Clinton Power Station

Clinton Power Station, Unit 1
Facility Operating License No. NPF-62
NRC Docket No. 50-461

Subject: Request for Amendment to Technical Specifications
Surveillance Requirements for the Main Steam Line Safety Relief Valves

DESCRIPTION AND SAFETY ANALYSIS
FOR PROPOSED TECHNICAL SPECIFICATION CHANGES

Figure 5.2-10. Schematic of Safety/Relief Valve with Auxiliary Actuating Device

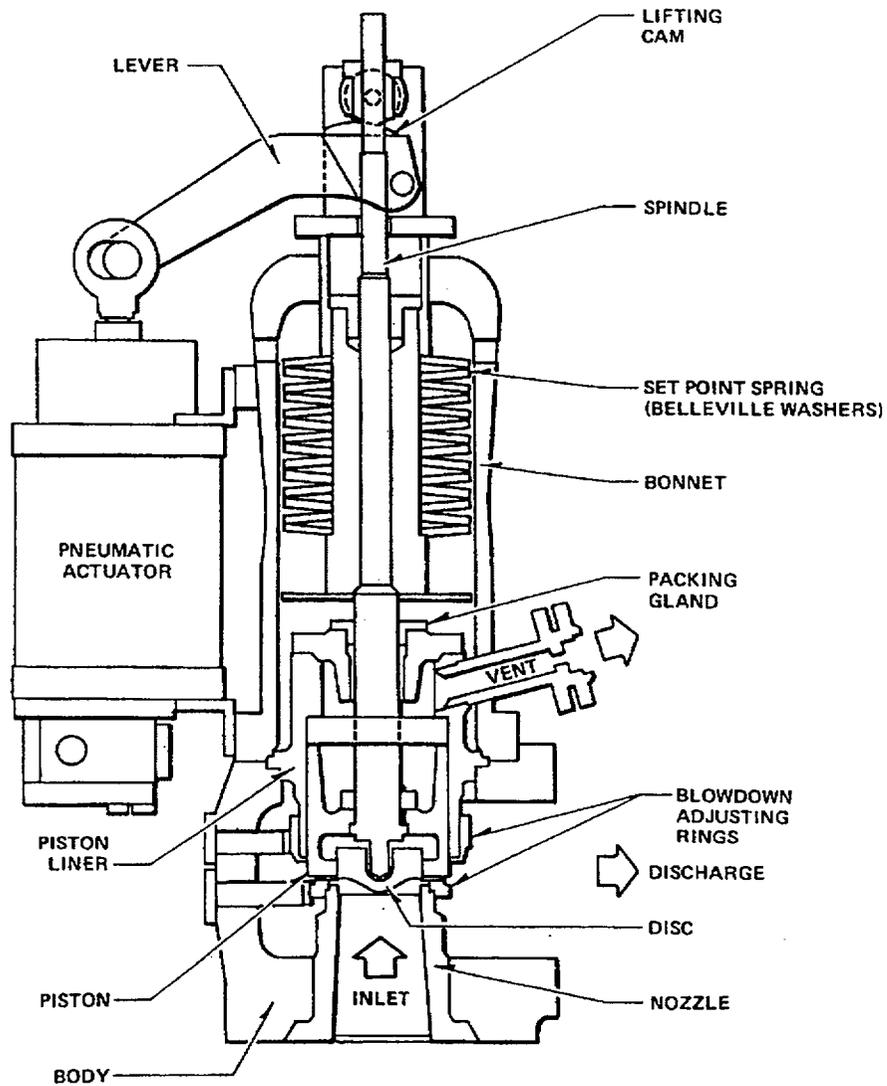
The proposed changes to TS SR 3.4.4.3, SR 3.5.1.7 and SR 3.6.1.6.1 remove the requirement that the valves open when the required SRVs are manually actuated, and replaces it with the requirement that the SRV valve actuators stroke on a manual actuation.

The SRVs at CPS are Dikkers 8x10, direct-acting, spring loaded, safety valves with attached pneumatic actuators. The SRVs are designed to perform as either a safety valve or a relief valve. The safety mode of operation is independent and separate from the relief mode. Major SRV valve components are shown on the attached Figure.

The proposed changes to SR 3.4.4.3, SR 3.5.1.7 and SR 3.6.1.6.1 will verify that the valve actuator for each SRV, ADS and LLS valve, strokes when manually actuated after the valve is installed in the plant. The testing will be performed with the actuator uncoupled from the SRV stem to allow the testing of the manual actuation electrical circuitry, solenoid and air control valve, and the actuator without causing the SRV, ADS or LLS valve to open. Following cycling, the relief-mode actuator is recoupled and the proper positioning of the stem nut is independently verified.
